August 1, 2024  
AVO 37449.004

**Re: Greystar Multifamily -Review #1**

Halff was requested by the City of Sanger to review the Final Plat and Civil drawings for the Greystar Muti-family Development. The submittal was prepared by Clay Moore Engineering and was received on July 18, 2024.

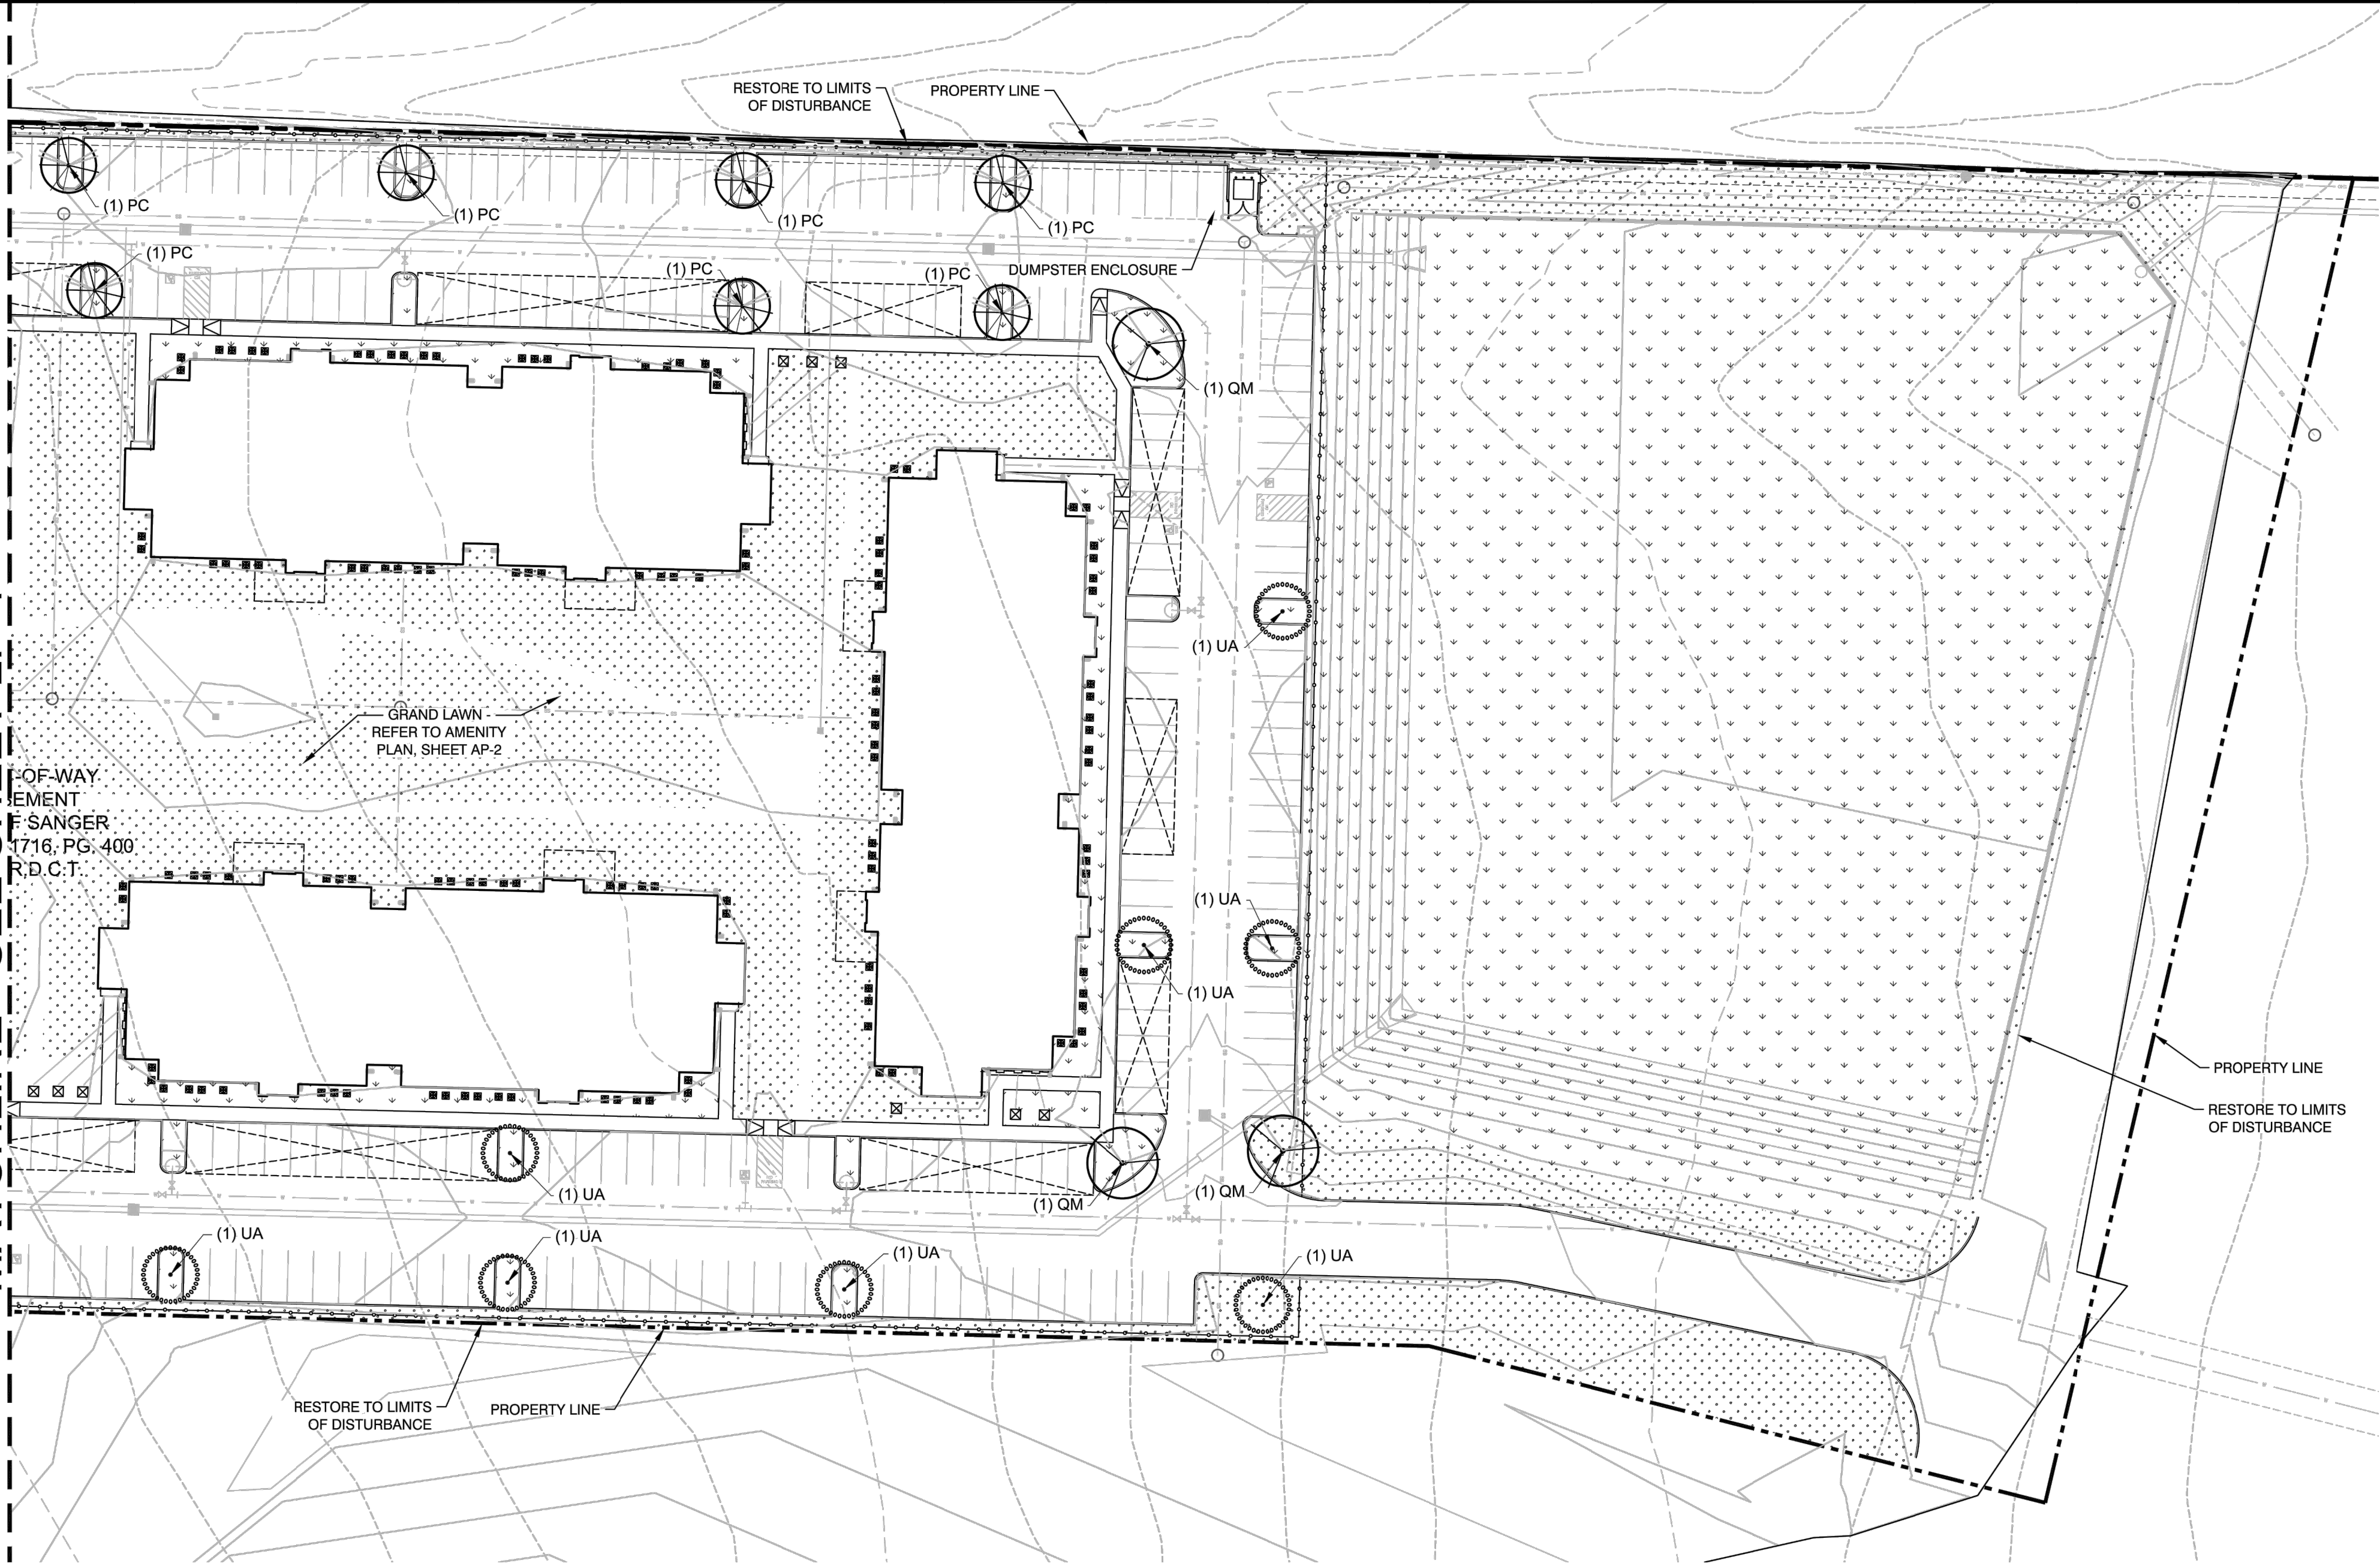
- Provide headwall details for storm outfalls
